OBJECTION TO STATE SIGNIFICANT DEVELOPMENT APPLICATION

SSD-97528708

142-148, 160 Oxford Street, 13 Gipps Street and 6 Shadforth Street, Paddington

Submitted by: Kate Armstrong, Owner-Occupier, 8 Shadforth Street, Paddington NSW

Figure 4 – Exhibit G_Architectural Design Report p62. Setback and intrusive views into 8 Shadforth.

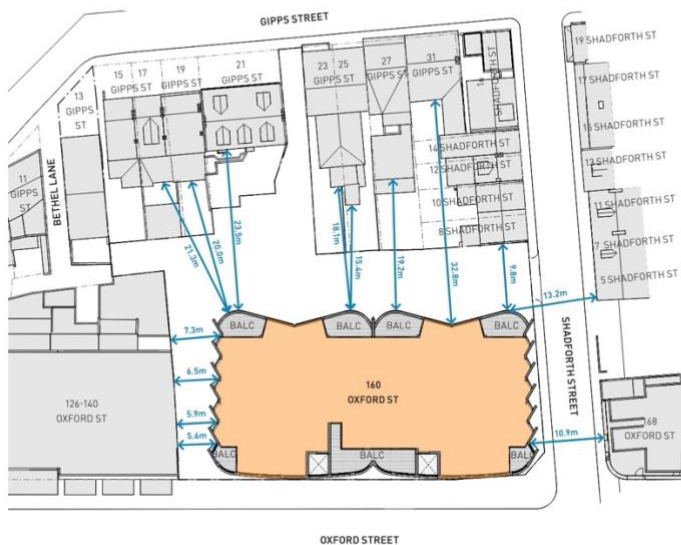
The proposed building will place north-facing balconies and habitable room windows, across eight levels, within 9.8 metres of 8 Shadforth Street, with separation falling below 9 metres at two further points along the boundary. The Apartment Design Guide requires a minimum separation of 18 metres between habitable rooms and balconies for buildings of 5 to 8 storeys (ADG, Design Criteria 3F-1). This development is 8 storeys plus rooftop. The achieved separation of 9.8 metres is little more than half the required distance. The proposal does not meet the ADG standard at any point along my boundary.

I note that the developer's Clause 4.6 Variation Request (Exhibit X_Clause 4.6 Variation Request, p.28) includes a claim that the proposal "generally aligns with ADG Objective 3F-1." On reading that document carefully, this claim is made specifically in relation to Gipps Street, the southern interface, not Shadforth Street, which is the eastern interface where my property sits. Additionally, the same document (p.24, Figure 10) shows a 9-metre building setback from the northern boundary and characterises this as achieving ADG separation requirements. It does not. ADG separation is measured between facing windows and balconies of adjacent buildings, not from the boundary of the development alone. If the development is 9 metres from my boundary, and my habitable rooms are a further 2 to 3 metres into my property, the actual separation between facing windows is approximately 11 to 12 metres. This is not ADG-compliant. (Exhibit X_Clause 4.6 Variation Request, p.24, Figure 10)

This overlooking is not a minor inconvenience. It means that every resident on the north side of the proposed building, across eight floors, will have a direct view down into my courtyard and into my dining room. No amount of angled blade screens or privacy fins will eliminate this.
